TENTATIVE TRACT MAP NO. 72029-CN (stamped map-dated September 27, 2012) and Case No. ZA 2012-2670(ZV)

HEARING DATE: Tuesday, January 15, 2013

PLANNING DEPARTMENT STAFF INVESTIGATOR REPORT

CASE NOs. TT-72029-CN, ZA 2012- 2670(ZV)  
TENTATIVE TRACT MAP, ZONE  
VARIANCE  
14601-14633 W. Magnolia Boulevard Van  
Nuys-North Sherman Oaks Community Plan  
Zone : R1-1, [Q]RD1.5-1  
D.M. : 171A151, 172-5A151  
C.D. : 2  
CEQA: ENV-2012-2668-MND  
Legal Description: Lot FR 379, Tract TR  
1000

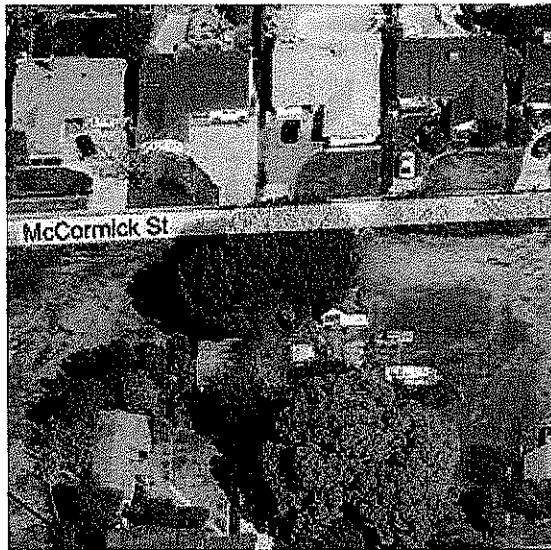
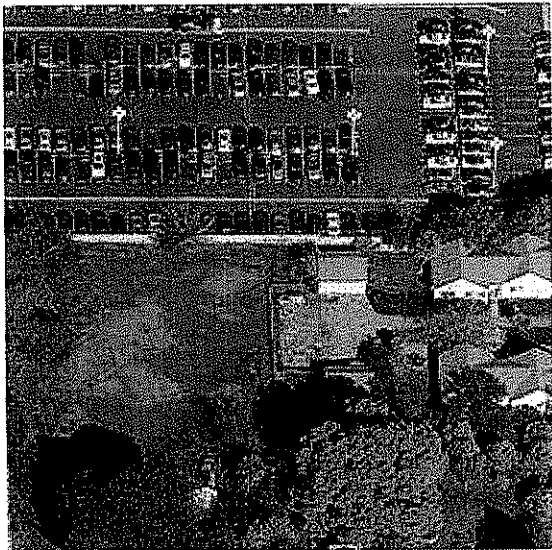
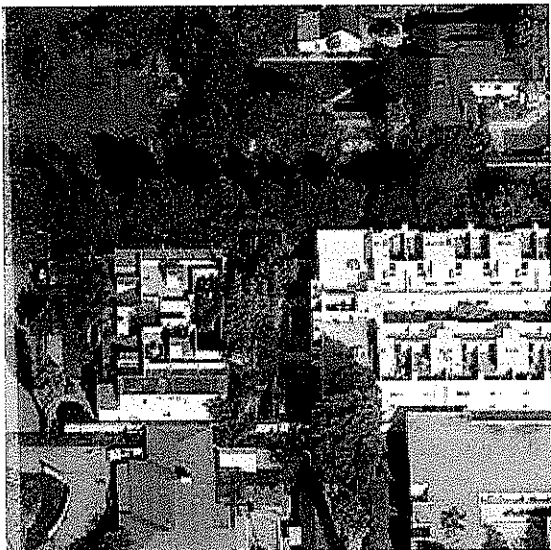
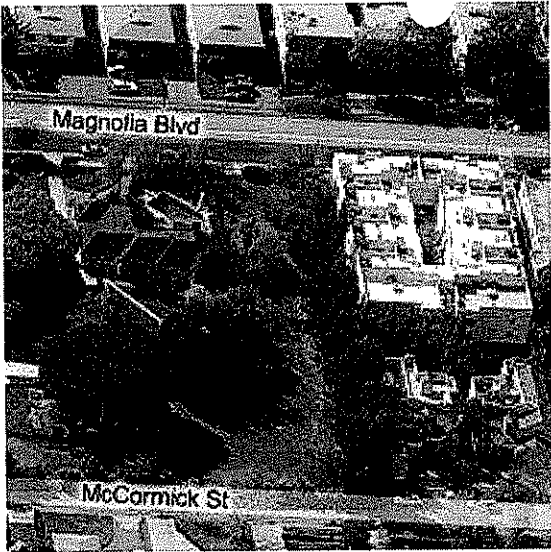
**BEFORE THEY RAVAGED THE LAND— NO REASON TO REMOVE THE NORTH / SOUTH EUCALYPTUS TREES (they admitted negligence)**

looking south and west trees sheltering 2 story house on west with the tall eucalyptus trees & the Live Oak tree which is the large stump seen in pictures 2,3,& 5
